MODIFICATION ASSESSMENT REPORT MOD 7675

Modification to the approved Stage 1B mountain bike trails, Thredbo Alpine Resort, Kosciuszko National Park

Modification (2) of DA 6571

June 2016

Figure 2: Start of new alignment of Trail 12, noting the approved Trail 12 alignment was located on the opposite slope (Source: Department site inspection photograph)

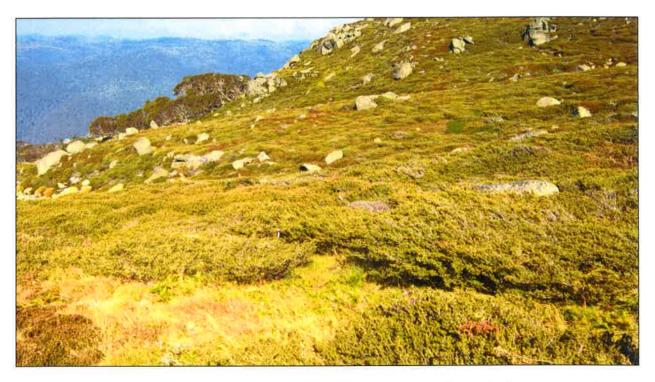
- reduces the slope of the trail and overall average grade;
- commences further along Trail 13 and therefore traverses more across contour at a longer length, requiring the installation of two bridges across Merritts Creek (Figure 2). The bridges will be the same as approved for Trail 13 bridges, constructed using the same method; and
- although longer than the approved trail, the approved trail was designed to also use the side
 of the Summer Road down to the start of the Downhill and Flow trails, so its actual length
 would have been more likely 510 metres rather than 370 metres as shown below. Therefore
 the difference in the two trails would be more likely around 50 metres.

Figure 3: Proposed alignment of mountain bike trail (green line) compared with approved alignment (yellow line) (Source: Applicant's MOD documentation)

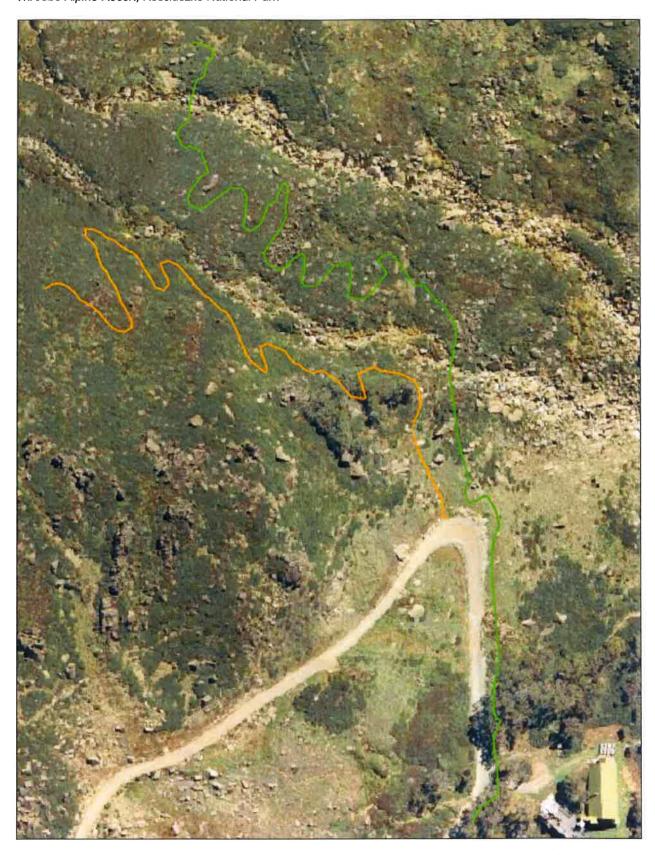
The OEH advised that the modified alignment is preferable when compared to the approved Trail 12, however requested further exploration of opportunities to reduce the number of switchbacks and the overall length of the trail. In addition, OEH requested a buffer be provided between the trail and the edge of the boulder field habitat that contains Podocarpus heath (potential habitat for the Mountain Pygmy Possums).

Comments received from the OEH, support the proposed realignment however requested a review of the number of switchbacks and recommending that a 5 metre buffer be provided between the trail and the boulder field, which has potential to be used by the Mountain Pygmy Possum.

The Applicant has previously provided justification for the number of switchbacks, however has agreed to minimise the number of switchbacks for the final alignment and will also review the location of the trail to provide a suitable distance up slope to the boulder field. It is noted that in accordance with the approved conditions, the final alignment of the trail is to be endorsed by the

On this basis, the Department supports the proposed amended alignment for Trail 12 rather than originally approved.
